Access Compliance Report

Public Rights-of-Way

Intersection ID: 46819	Main Street: CLAUDE FREEMAN DR	Cross Street: AZALEA HILLS DR	Location: NW
ADA ID: F28E49A08A87	Ramp Type: PerpDiag	Initial Pass/Fail: Fail	Overall Compliance: No
			Severity Score: 31.25

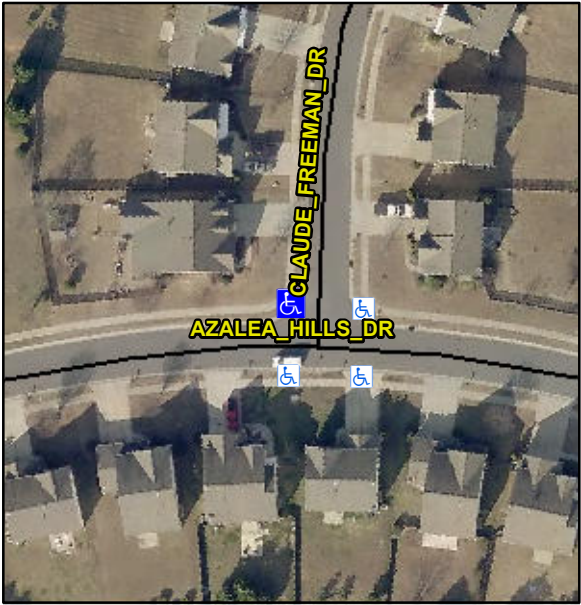
R304.5.1, R304.2.2, R304.5.3

Remove & Replace Curb Ramp With Two New Directional Ramps or Equivalent.
